January 6 1917

Carroll Dam

Specifications for Building Carroll Reservoir
Dam for the Volcan Land & Water Co.

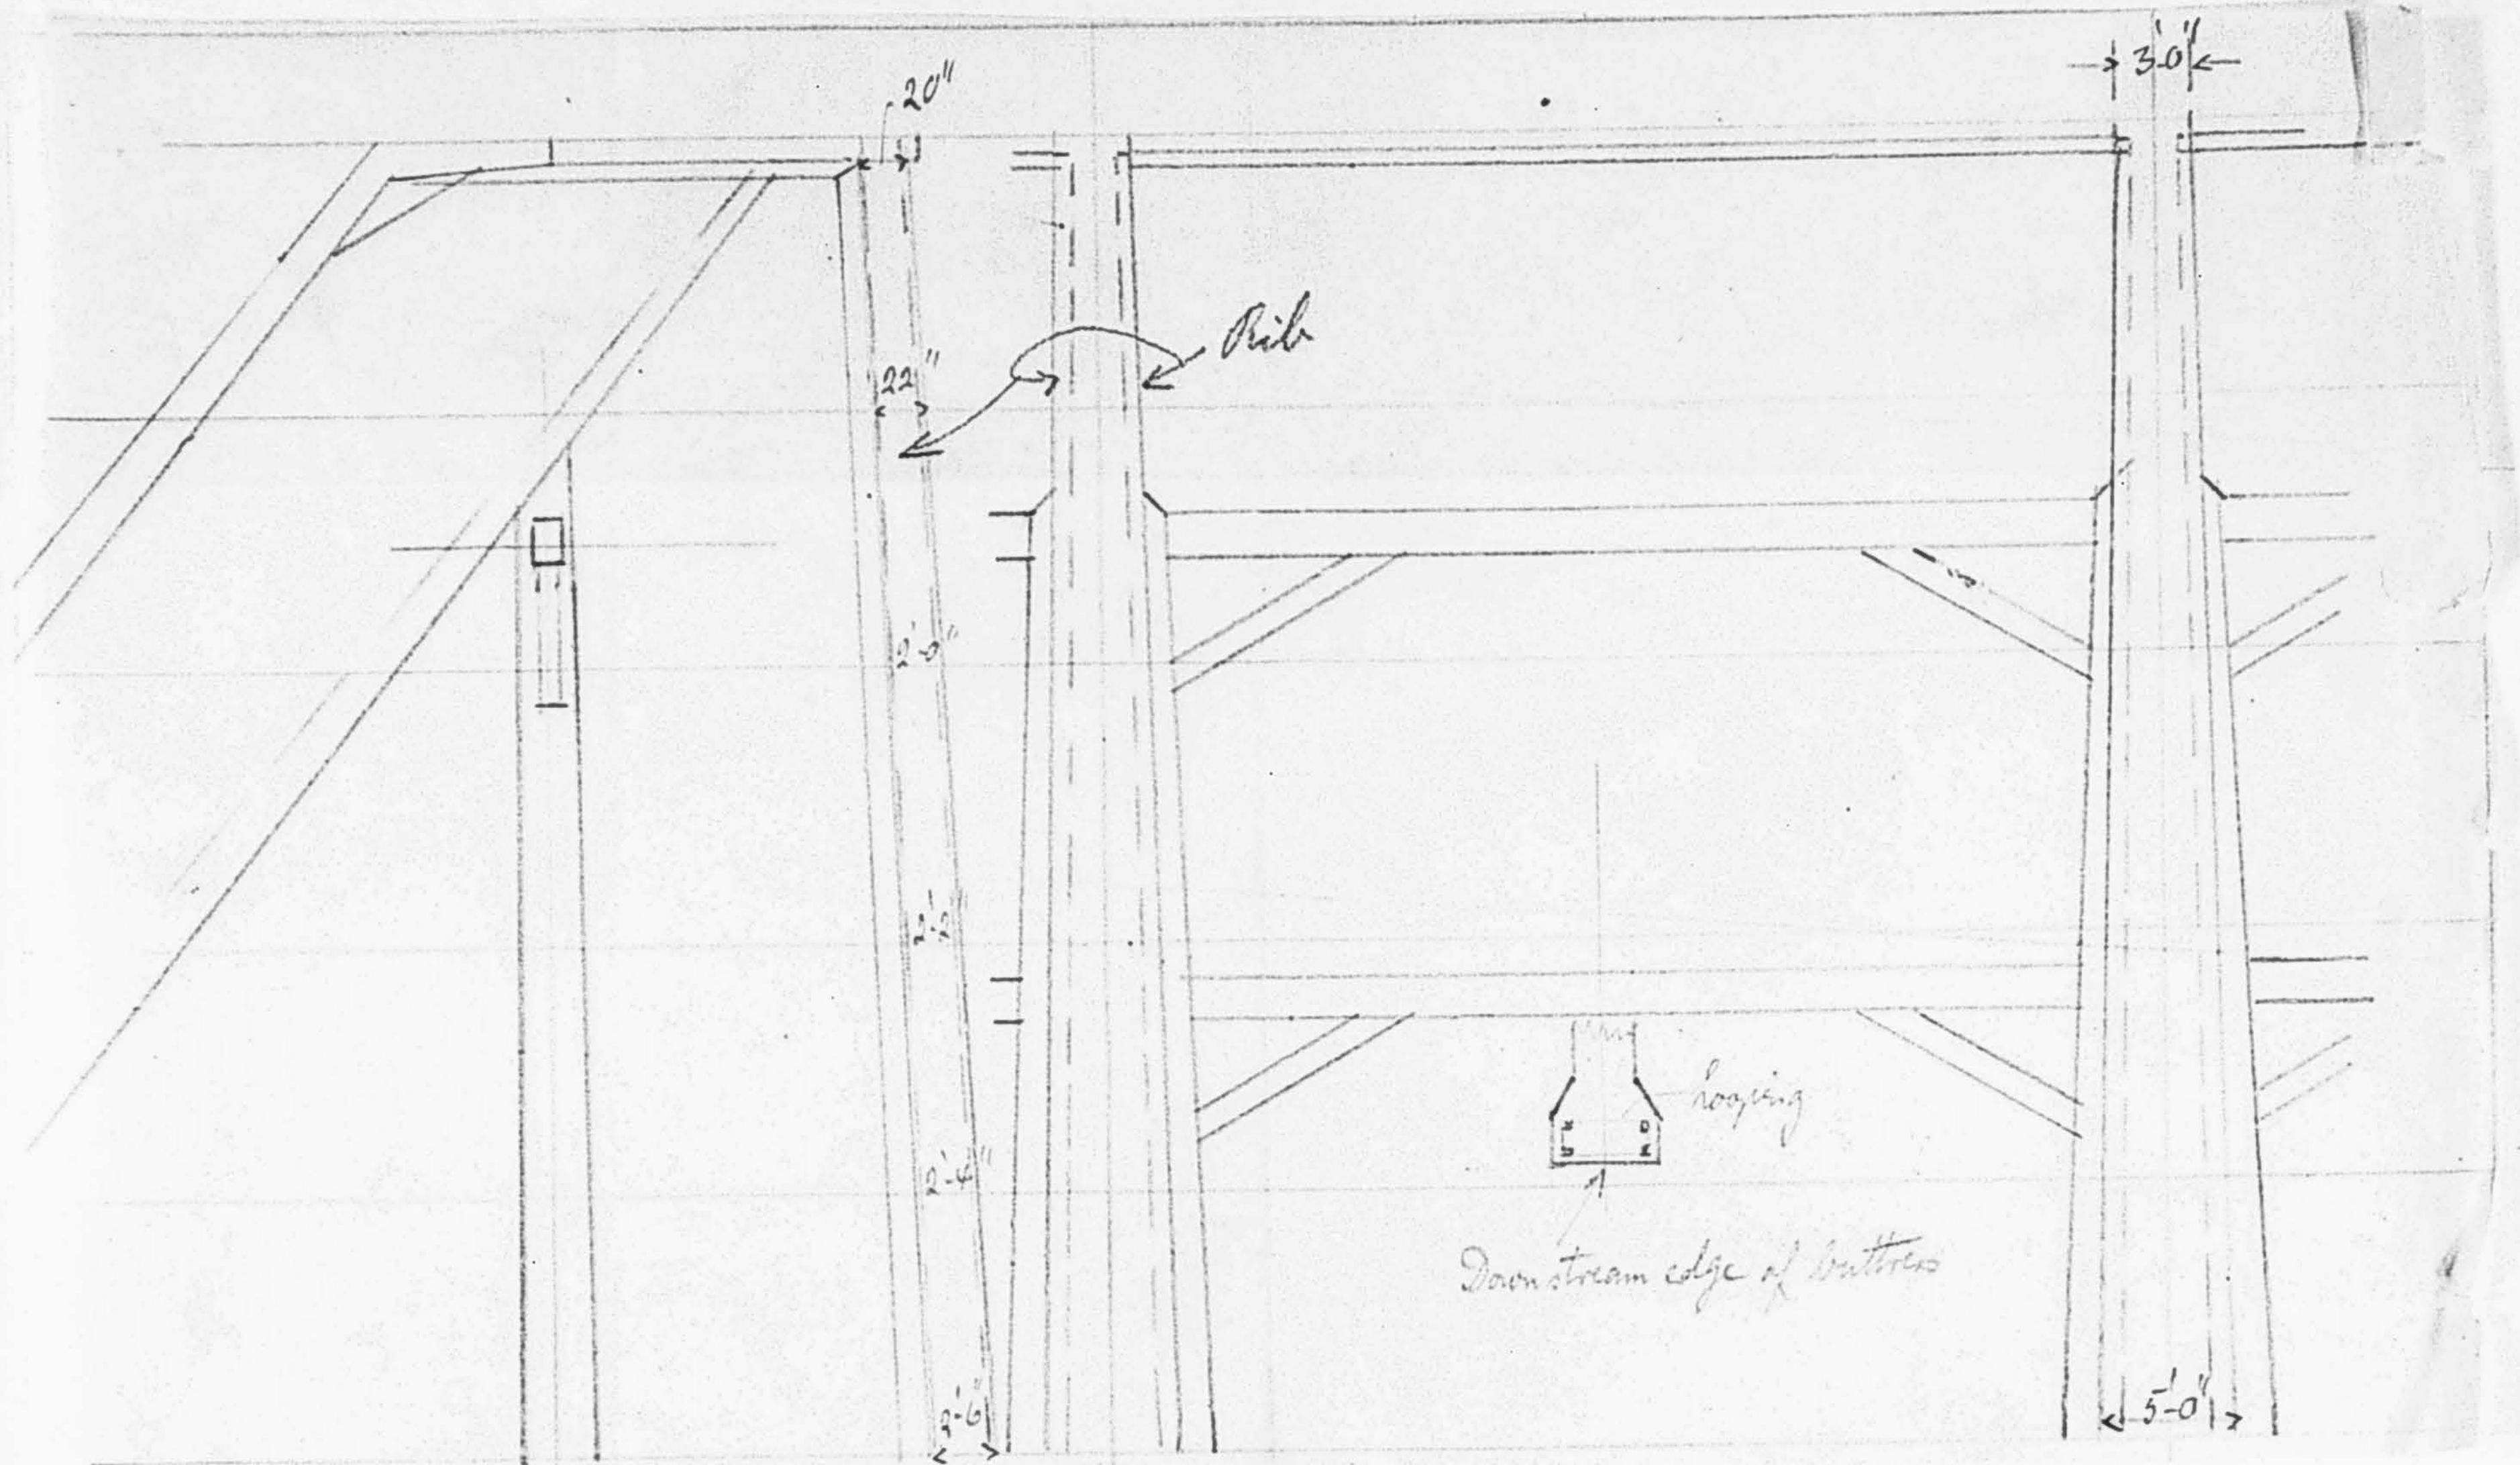
I am enclosing a sketch showing a rib ,that I am putting on both sides of the buttresses at the downstream edge.

This is to take care of any possible windstresses. While these may be somewhat problematical,they ought not to be neglected.

This adds 2,5 tons of steel and 60 yards of concrete. I think the ribs will also add to the appearance of the structure.
